Product Change Notification

NOTIFICATION NO.	ISSUE DATE	LAST BUY DATE	LAST SHIP DATE
EU-PCN-20250701-01	01.07.2025	---	---

Reflective and transmissive photointerrupters, please see the attached list of affected models.

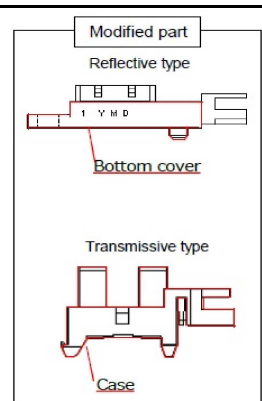
Due to our efforts to address environmentally hazardous substances, we will be changing the resin used for the cases and bottom covers of certain photointerrupters from PFAS-containing to PFAS-free.

The resin for the bottom cover will be changed.

The resin for the entire case will be changed.
